PLANT NAME: OCONEE UNITS 1 - 3
jcm 01/04/78

Consists of response to questions
forwarded in NRC's ltr of 11/23/77 concerning
the Steam Generator Tube Leakage Safety
Assessment Rept...

RE: Oconee Nuclear Station
Docket Nos. 50-269, -270, -287

The attached information is in response to questions forwarded in your letter of November 23, 1977 concerning the Steam Generator Tube Leakage Safety Assessment Report which was forwarded by my letter of September 9, 1977.

FIGURE 1: RCS AVERAGE COOLANT TEMPERATURE VS TIME

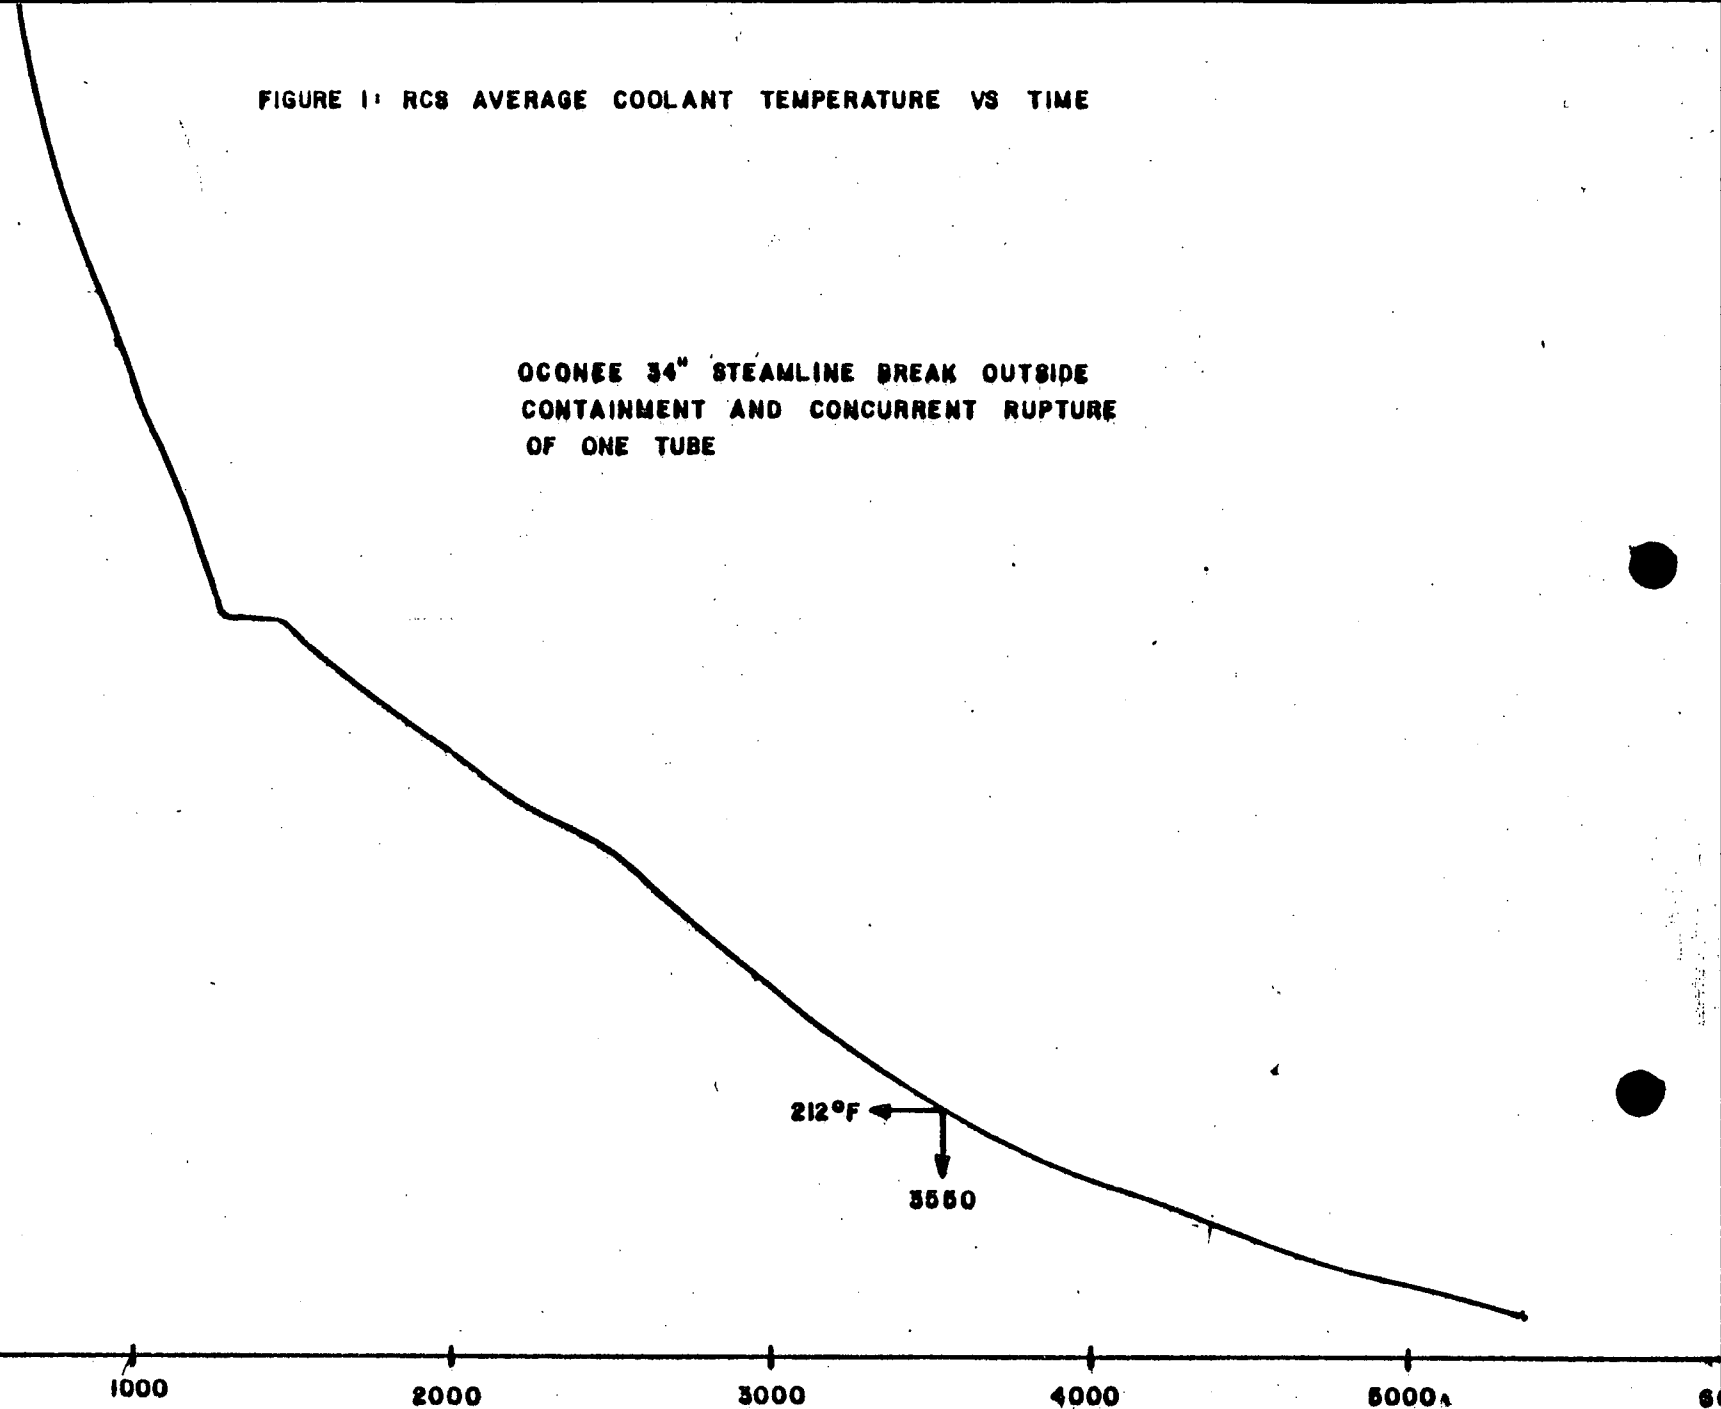
Your report states that operator action to switch off the safety injection would be conservative because it results in minimum dilution. Justify that this action is conservative. Explain the effect of delaying this action. The concern is that continuation of the safety injection will keep the system pressure at a higher level and would result in higher releases, in spite of the increased dilution.

This appears to be particularly important for the cases of one and three tube failures for which the leak rate is calculated to be increasing at a high rate at the time that the safety injection is switched off.

Analyze this accident assuming different times for operator action (e.g., 10 min., 20 min., etc.)

The calculated leak rates, RCS coolant temperature, and RCS pressure beyond 600 seconds are shown in the Figures 1 through 3 respectively. The average coolant temperature of 212°F is reached by 3450 seconds. The primary pressure reaches 25 psia by 5368 seconds corresponding to a total leak rate of 4.82 lbm/sec which was assumed constant thereafter. Once the RCS temperature falls near 212°F , the secondary side of the steam generator would start filling with water.
